7 February 2002

Subject: Comments on Recently Received Documents Pertaining to
Seattle Tacoma International Airport Project
Third Runway – Low Flow Analysis

Figure 1 - SeaTac Embankment Fill Grain Size Analysis

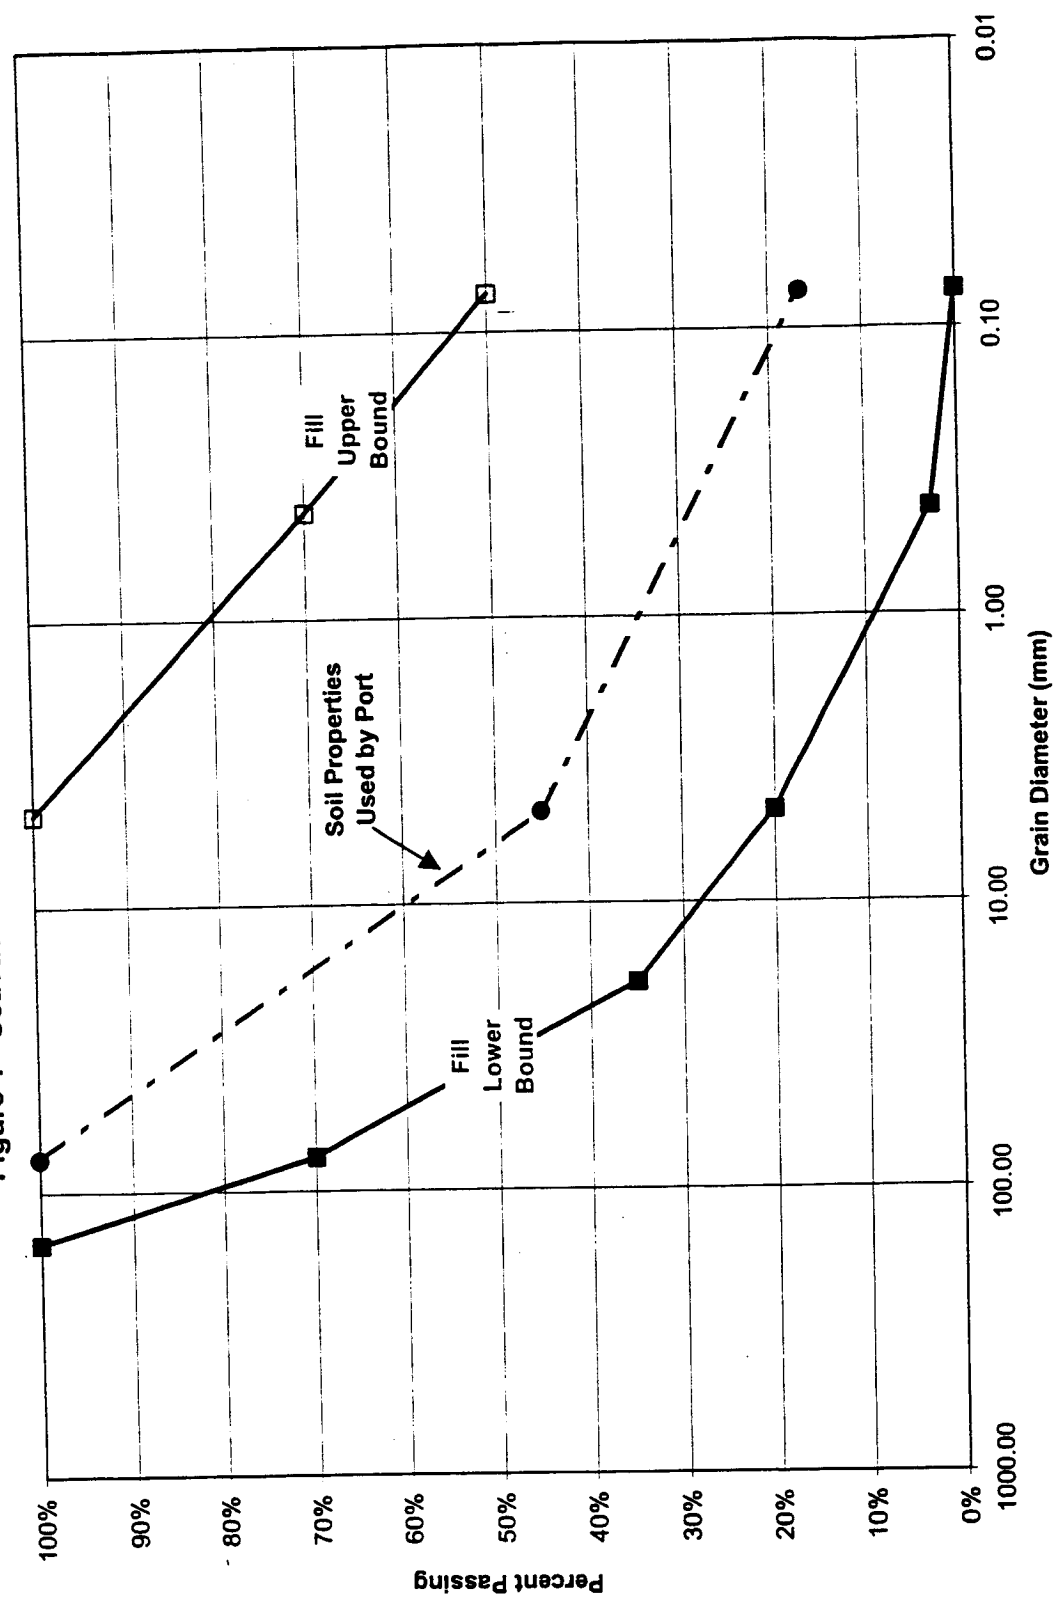
Comment 2: The analysis relies on a single set of soil parameters to represent the behavior of 20 million cubic yards of fill that will be obtained from numerous different borrow sources. This is a gross oversimplification and will lead to significant discrepancies between the predicted streamflows and those that would actually occur after construction.

The attached Figure 1 presents the range of soil grain sizes allowed by the project specifications and presents the single grain size representation used in the low flow analyses. Fill placement during construction of the embankment will occur in horizontal layers. As a result, there will likely be large areas of fill with fine-grained, low hydraulic conductivity material which will control the rate at which water flows vertically through the embankment. The overall hydraulic conductivity of the actual soil in the embankment could be several orders of magnitude less than that assumed for the current low flow analyses. This difference in hydraulic conductivity will have a substantial effect on the predictions made in the current analyses.

The current low flow analyses should not be accepted without a proper parametric evaluation of the influence of soil parameters on flow paths and travel times. A comparison of the soil parameters used for the low flow analyses and the range of soil types allowed for construction indicate that the flow rates through the embankment will be significantly more variable than the current analyses would indicate. That variability will likely increase the vault storage volumes required to protect low flow conditions in the creeks.

Figure 2a: Van Genuchten Parameter Variability

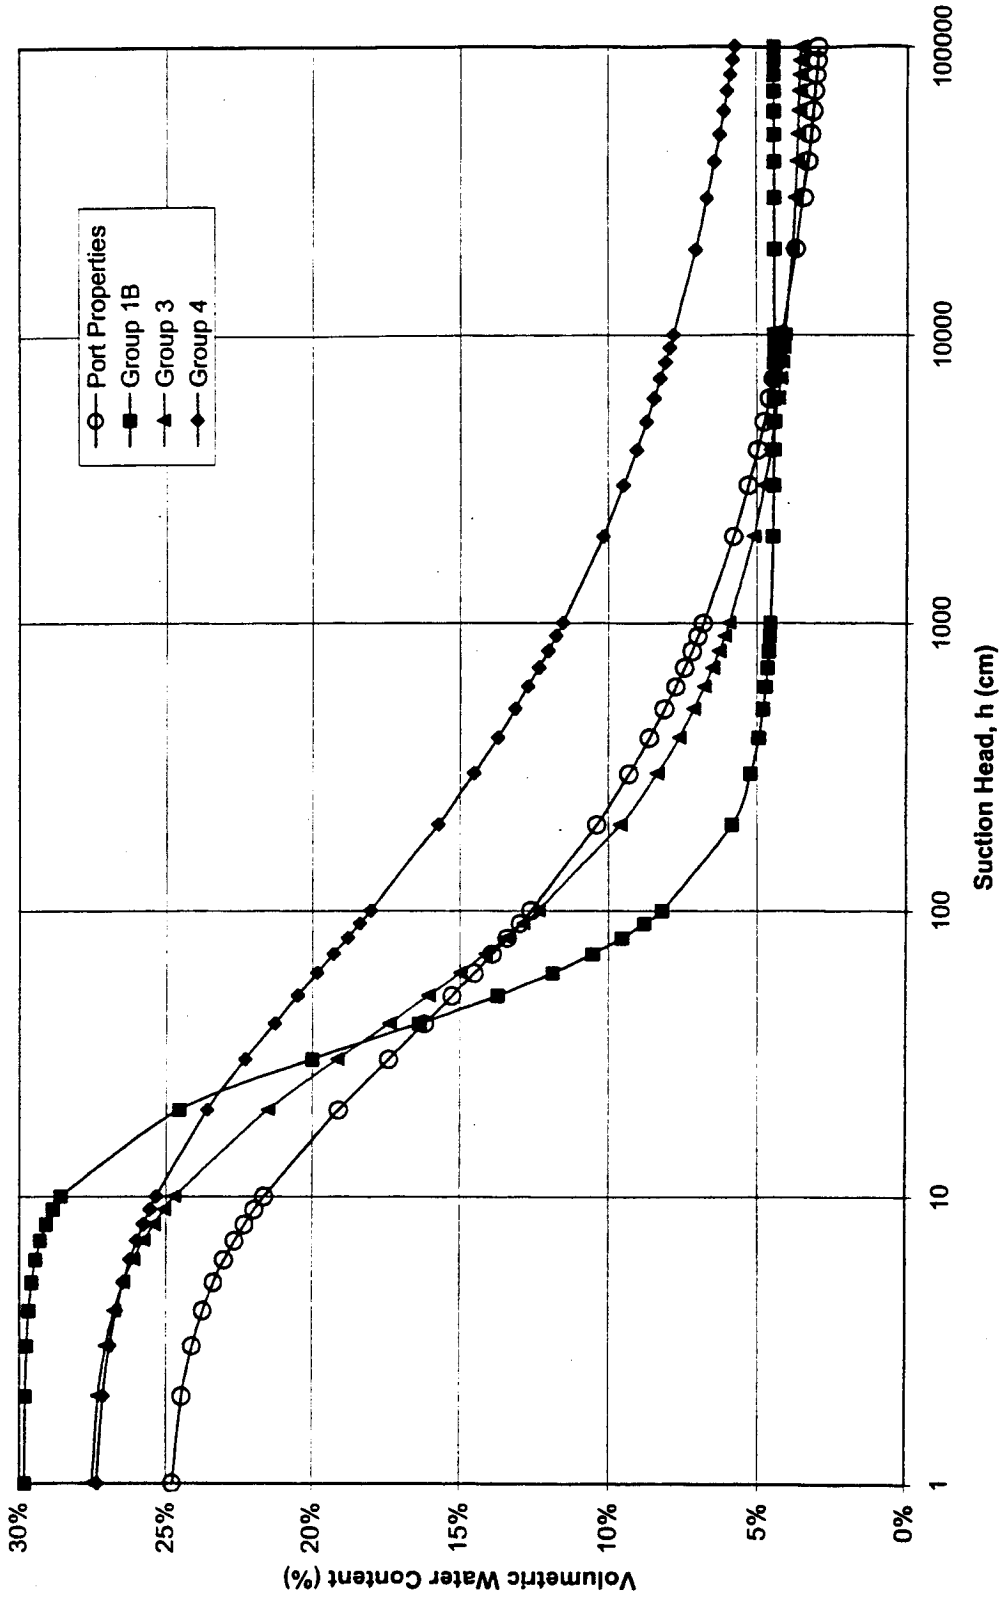
In Hart Crowser's "Embankment Infiltration and Seepage Studies" report², they presented unsaturated flow parameters and corresponding unsaturated behavior curves for three of the fill types proposed for the embankment (Group 1B, Group 3, and Group 4). Figures 2a and 2b present the representative curves developed by Hart Crowser for the three fill types, along with the single set of curves being used presently by PGG in their Hydrus modeling (labeled "Port Properties"). While Hart Crowser's modeling with the HELP program was overly simplistic and their method of accounting for gravel content was not well validated, their performance of parametric studies on the fill types was a step in the right direction compared to the single fill type currently being modeled in Hydrus. The Hart Crowser properties show that the hydraulic conductivity (which controls the rate at which water will pass through the fill) can range over several orders of magnitude for soils likely to be placed in the embankment. The figures clearly show that the single curve being used by the Port is not representative of the potential range of behavior.

Figure 3: 1-Dimensional Column Initial Lag Times for Infiltration to Reach Drainage Layer under Varying Soil Properties and Column Heights

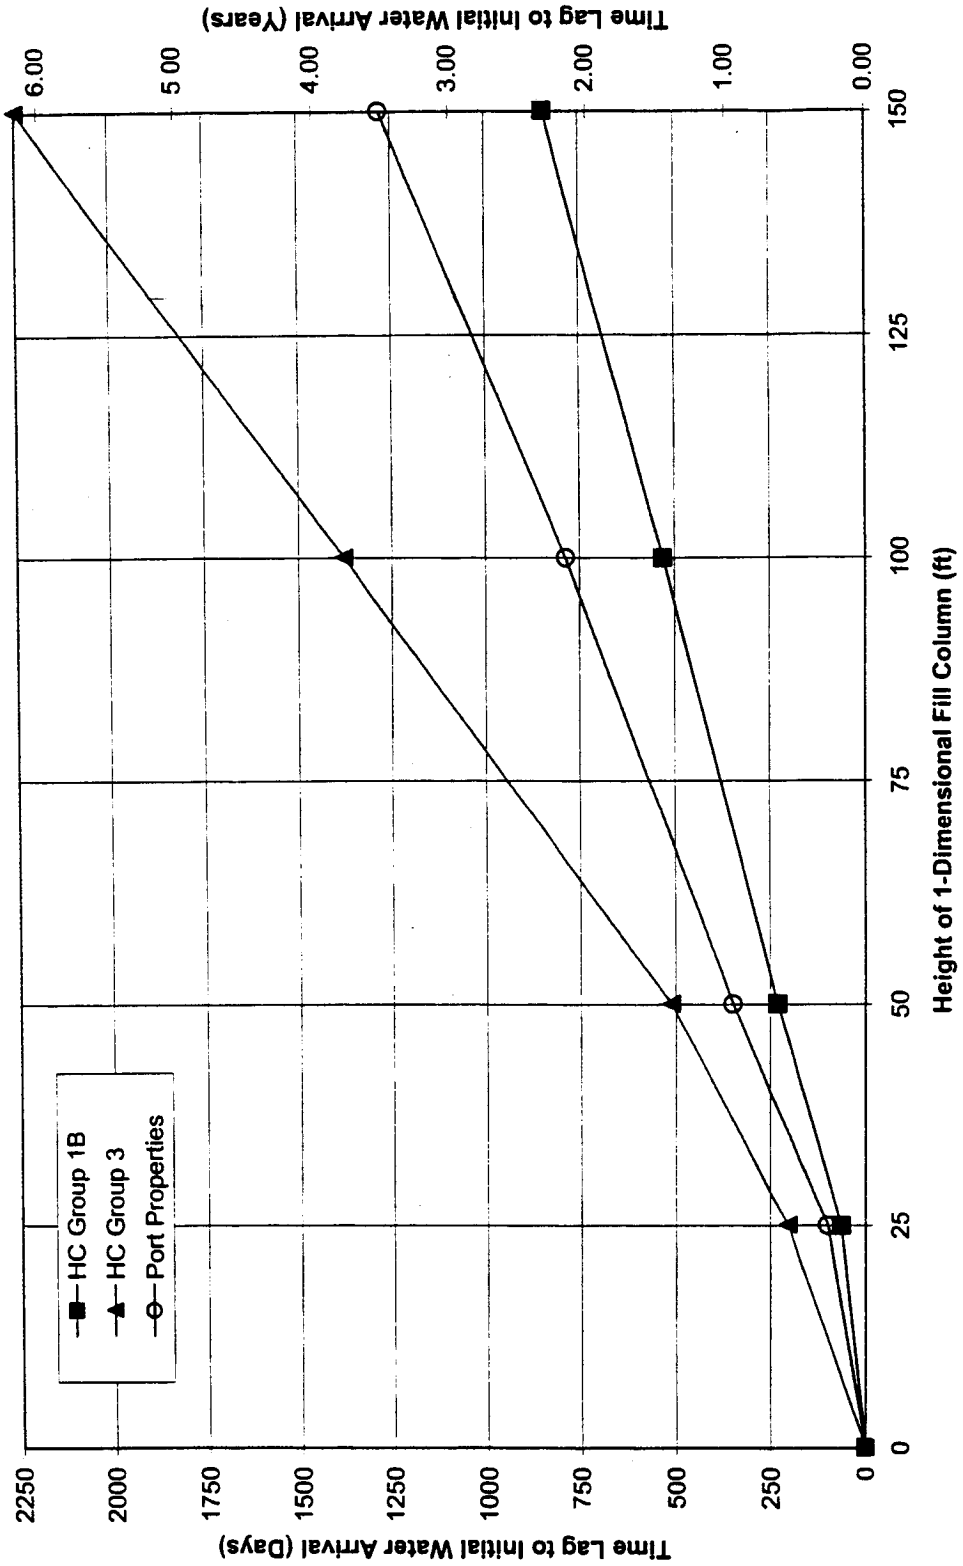
In order to demonstrate the influence of the variability of soil properties on the lag time between embankment construction and first arrival of water at the drain, several simple cases were analyzed. 1-Dimensional columns of varying fill thickness (25 ft, 50 ft, 100 ft, and 150 ft) were modeled using Hydrus for three different sets of fill properties (Hart Crowser Group 1B, Hart Crowser Group 3, and the Port Properties). The 1-Dimensional columns were modeled in a fashion similar to the Port's analyses, where all infiltration was assumed to travel vertically through the fill, without an allowance for horizontal flow. Figure 3 shows the results of these analyses. A curve is shown for each set of properties, immediately revealing the potential for variability in the results. Each point on the curves represents the time between the beginning of the analysis (Day 0) when the precipitation record begins, and the time when the first water reaches the drain at the base of the column. As the height of the 1-Dimensional column is increased (i.e. as the embankment fill thickness increases) the time lag increases relative to the properties for each fill type. For example, for a 50 ft fill thickness, the range of time lags shown is 250 to 500 days (approximately 0.7 to 1.4 years), and for a 150 ft fill thickness, the range is 850 to 2250 days (approximately 2.3 to 6.2 years). It will be shown later that ignoring the horizontal flow component in the fill (i.e. performing a 1-Dimensional analysis) results in an overestimation of the rate at which water flows through the fill, and thus the predicted lag times will actually be even longer than these values. In any case, the differences clearly demonstrate the potential variability in results which the port is ignoring in their analyses. Incorporation of this type of

parametric study in the Port's analysis will likely have a significant impact on the design of the Port's low flow mitigation scheme and is absolutely necessary for proper representation of the possible impacts of the embankment fill.

Figure 4a: Current Model System, all flow travels vertically through sand & silt matrix

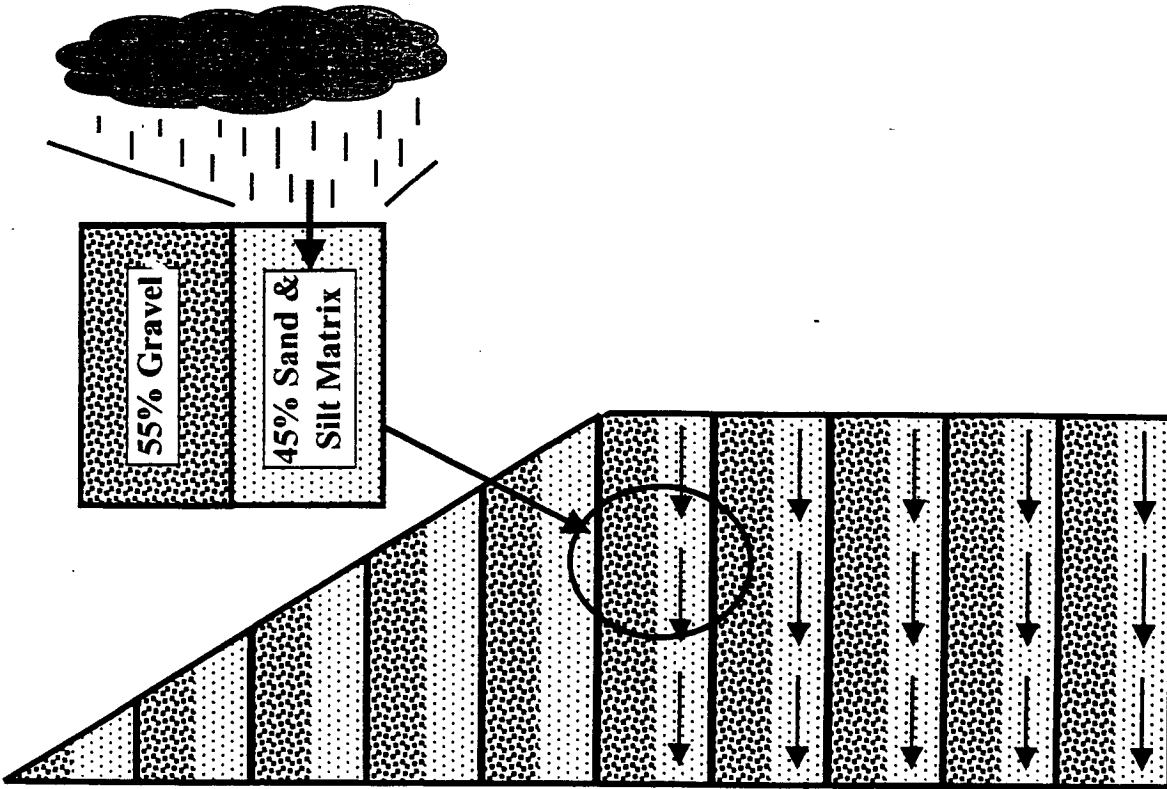
Comment 4: The Port's method of modeling of flow through the fill as a 1-Dimensional phenomenon using Hydrus is an oversimplification of a truly 3-Dimensional process, and will result in an overprediction of the rate at which water travels through the embankment.

In addition to the Port's ignoring the gravel content of the embankment fill, their analysis consists of a series of 1-Dimensional columns of soil of varying thickness which force the infiltrating water to travel downward unimpeded without any lateral migration. Figure 4a shows a schematic of the system the port is actually modeling. Each column theoretically consists of 55% gravel and 45% sand and silt. However, water falling on any given column of soil is forced through the sand and silt matrix (achieved through artificial adjustment of precipitation and discharge quantities), bypassing the gravel completely. It should also be noted that water falling on the sloping face of the embankment is assumed not to infiltrate at all, and because the water can only travel vertically, this region never sees any water at all.

Figure 4b: More realistic scenario, flow paths change continuously throughout profile

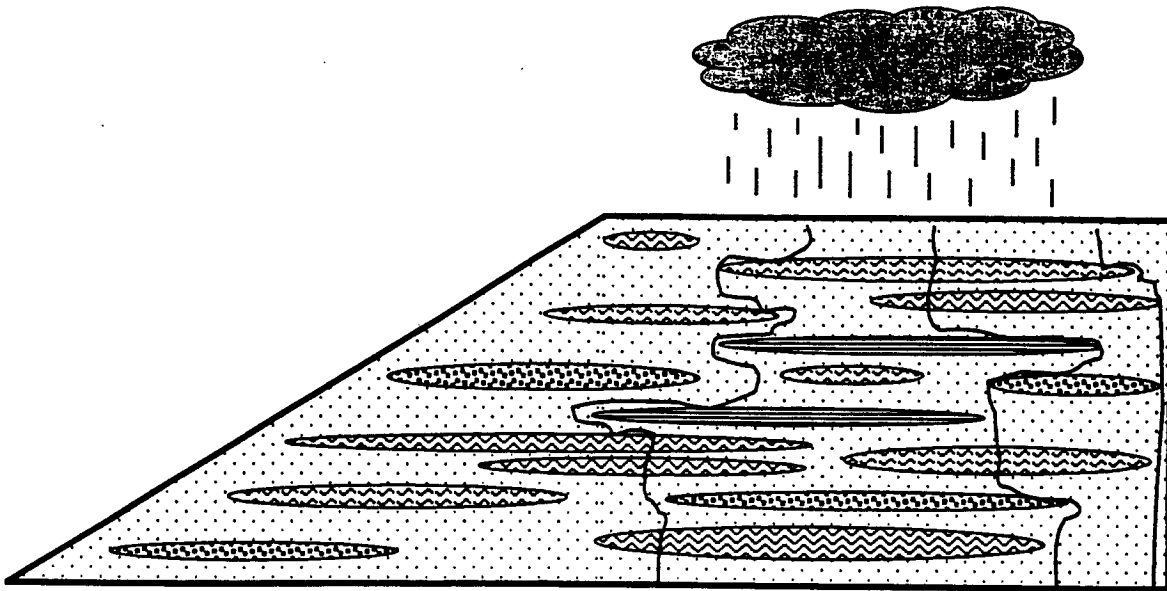
Figure 4b shows a schematic (which is still a simplification) of the type of layering that will exist in the embankment fill as a result of the construction process. 20,000,000 cubic yards of fill will be imported from numerous borrow sources and placed in horizontal layers at the then current elevation. The soil layers with the lowest hydraulic conductivity will control the vertical rate of flow of water traveling through the embankment. It will be impossible for the Port to control the fill sufficiently that an assumption of uniform flow behavior can be assumed realistically. The Port has failed to consider the very real variability of the soils that will be placed in the embankment. As a result of the fill layering, the flow path will be significantly more complex than

represented by the Port (e.g. Figure 4a), and the time for water to travel through the embankment will be much slower than predicted.

**Figure 5: Moisture Content Variation Over Time for Cross Section 2
Using Hart Crowser Group 3 Embankment Fill Properties**

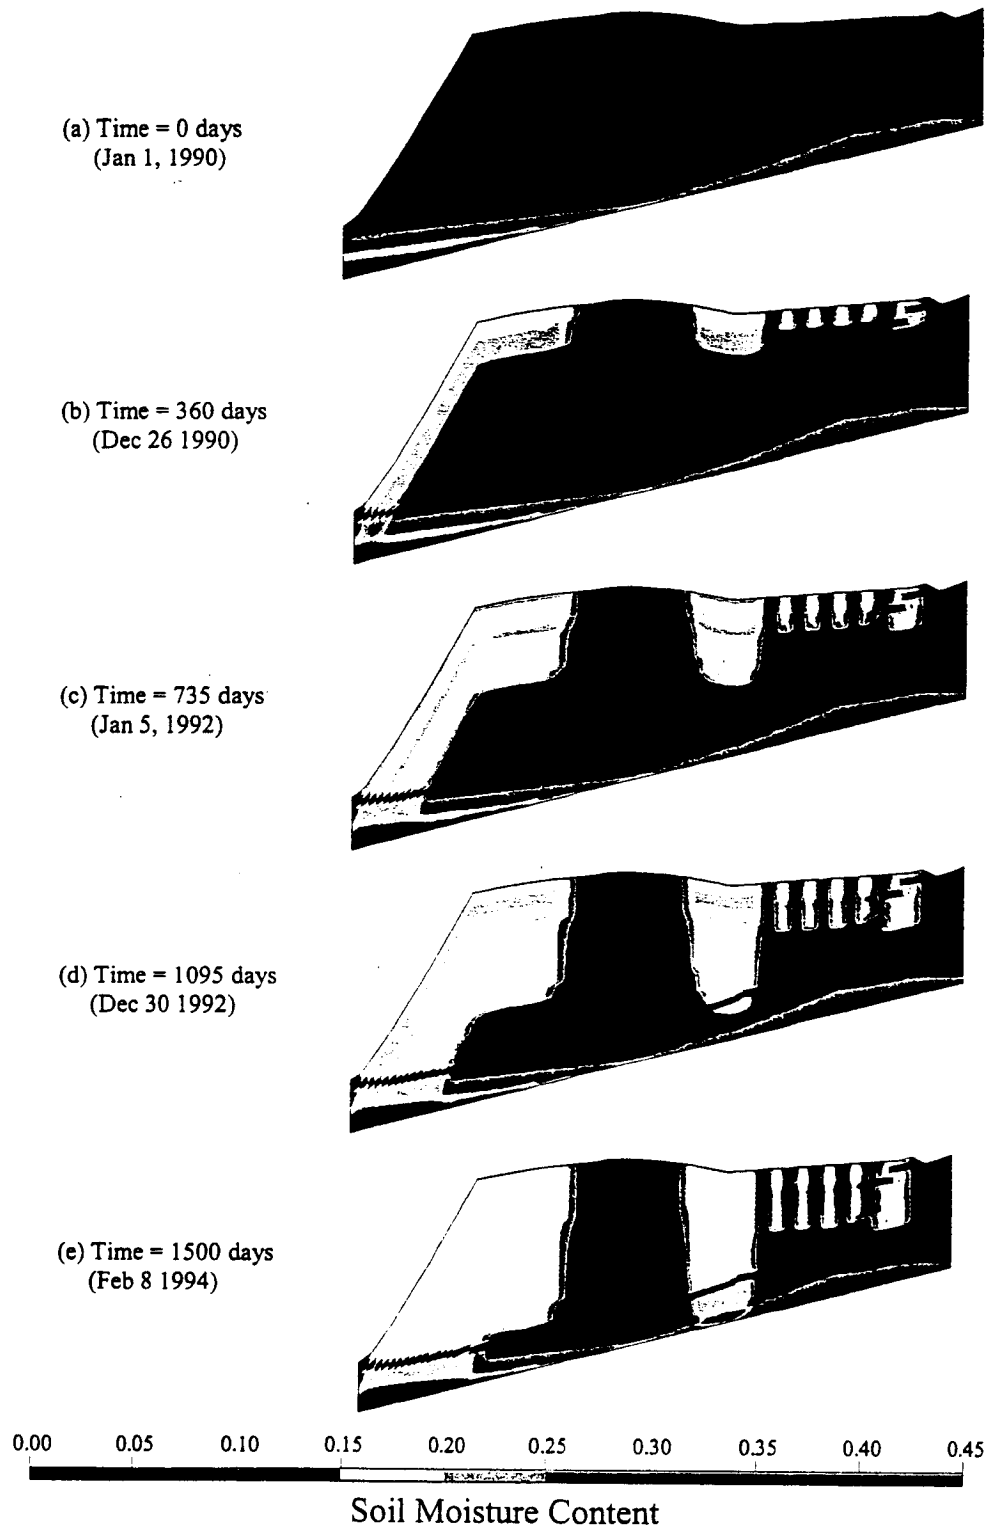
Figure 5a presents a schematic of the Hydrus model cross-section being used by GeoSyntec, which is based on PGG's section 2, with an embankment fill height of up to 110 ft. The embankment fill, the drainage layer, the outwash layer, and the underlying till are all being modeled within Hydrus. The model is being run using approximately four years of daily precipitation data (January 1990 through February 1995) from the SeaTac airport. No runoff or evapotranspiration calculation has been made, so all precipitation is assumed to enter the embankment.

Figures 5a through 5e present preliminary results using the Hart Crowser Group 3 fill properties described in Comment 2. The lighter colored front that progresses downward over time represents the propagation of the infiltrating precipitation. It is clear that the water infiltrating near the face of the slope, which has a shorter travel path to the drainage layer has already begun to reach the drain and then the creek by approximately 1 year after the modeling begins (Figure 5b). However, the flow under the thick majority of the embankment is only beginning to reach the drainage layer between 3 and 4 years (Figures

5d and 5e). With the uniform soil profile assumption relied upon by the Port, there is only slight evidence of horizontal flow of water, although Figures 5b through 5e show a gradual narrowing of the dark colored band of dry soil beneath the runway, indicating that moisture is gradually working its way laterally. This effect can also be seen in the flow of water between the filter strips on the right side of the model. The significance of this lateral flow component is that water will travel within the embankment fill for longer periods of time prior to reaching the drain and the creeks than with analyses limited to vertical flow only. The Port, using their simplified analyses, has reported none of these trends.
